3070-86

S E R V I C E   N O T E

Agilent Medalist i3070 and i3070 Series 5 In-Circuit Test System

New firmware for i-system card (P/N: N1807-63603) to retain fixture lock position when reboot

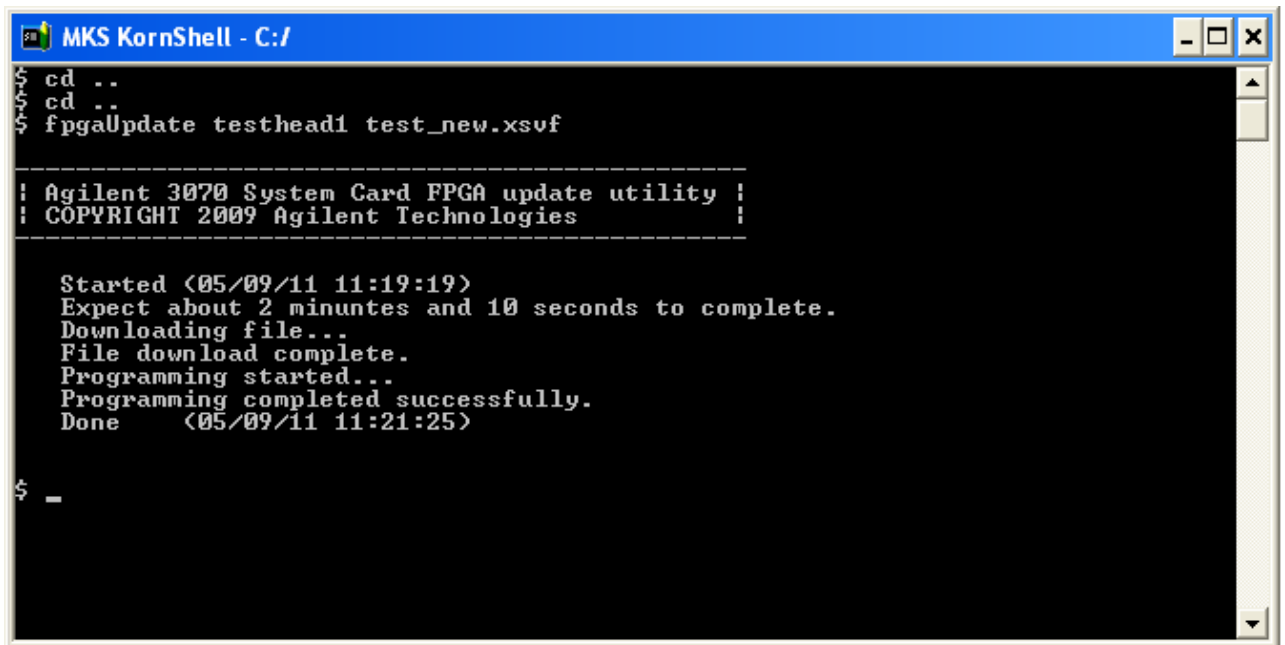
The "i-system card" (P/N: N1807-63603) used in the i3070 testhead will automatically unlock the fixture whenever the user executes or reboots the testhead with the "testhead power on" command.

This new firmware will solve the auto unlock issue by retaining the fixture position during soft reboot or execution of the "testhead power on" command.

1. Download and unzip the "i_system_card_firmware.zip" files into any directory from www.agilent.com/find/i3070patches.
2. Switch on the testhead but DO NOT boot up. (Hint: Do not type "boot" or "testhead power on")
3. In kornshell, navigate to the directory and execute "*fpgaUpdate testhead1 test_new.xsvf*"
4. When done, recycle the power to i-system card by first switching OFF the testhead and then switching it ON again.
5. Boot up the testhead.
